Algonquin Backcountry
Recreationalists

Comments Regarding the Algonquin Park 2010-2020 Forest Management Plan

Totem Lake, Wilkes Township

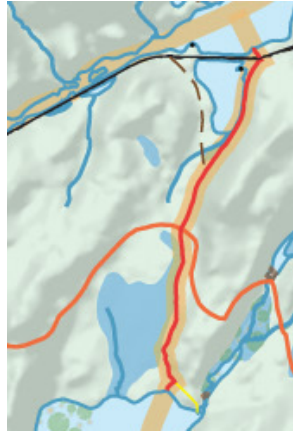
Totem Road is proposed to be constructed through the portage between Upper Kawa Lake and Totem Lake for a total of approximately 220m. Rather than simply crossing the portage, this proposed road replaces the portage for one quarter of its length.

Little McCraney & Rain Lake, McCraney Township

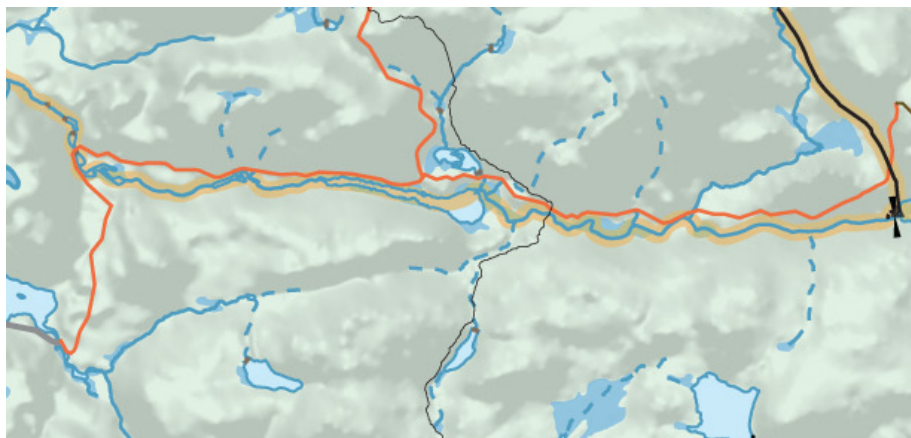
Little McCraney Lake Road is proposed to be constructed paralleling the portage between Upper Kawa Lake and Totem Lake for a total of approximately 500m at a distance of 50m. As defined by the Algonquin Park Management plan, roads within 120m of portages are crossings yet this represents just under one third of the length of the portage.
